Slugfest Amendment #1

The following are additions and changes to the Slugfest Manual.

Slugfest Amendment #2

Slugfest Amendment #3

If you are going to change coinage

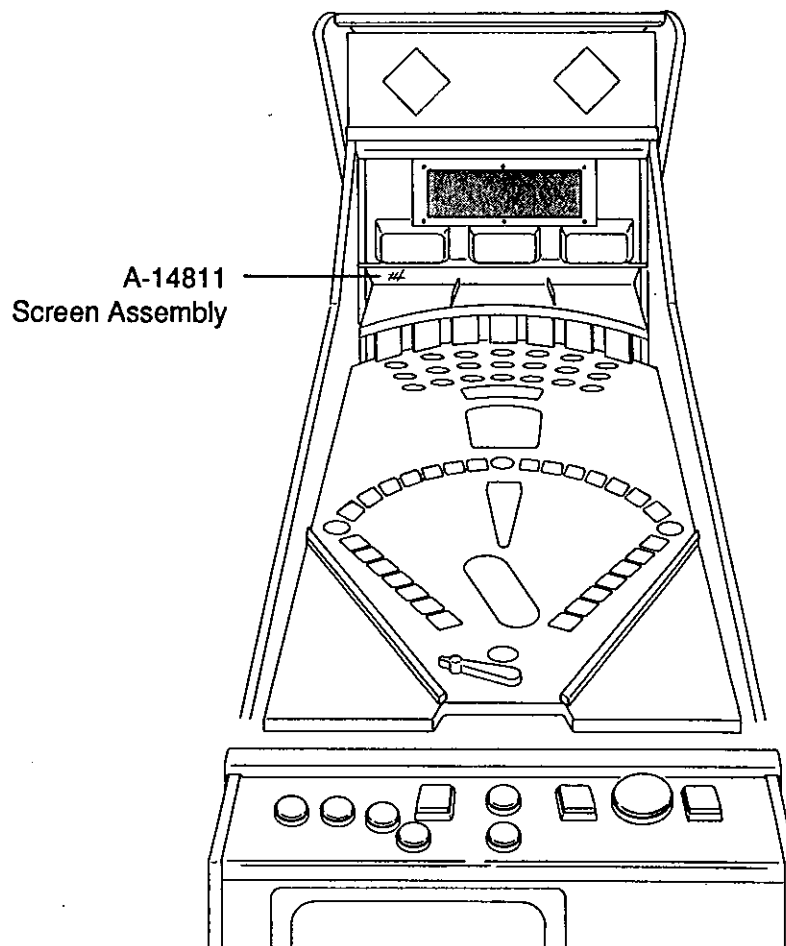
If you wish to change the coinage, you can choose a variety of preset coinages at the end of the "Utilities Menu" under "Presets Menu", or create one of your own. Remember, that changing the coinage also effects the dispenser rate. So, if you change the 9 Inning Cost, change the Ticket Award Adjustments (in the Dispenser Adjustments Menu) proportionally. For Example: If you increase the cost of the game, say to \$4.00/9 Innings from \$2.00/9 Innings, then double the initial ticket awards (except for the "Ticket/Game Start" and "Ticket/Buy-in"). Also, if you buy More or Less Innings with 1 coin, then proportionally increase the runs on the four "Run Levels". For Example: Changing from 25¢/1 inning to 25¢/3 Innings, it is recommended to also multiply the number on all four "Run Levels" by 3.
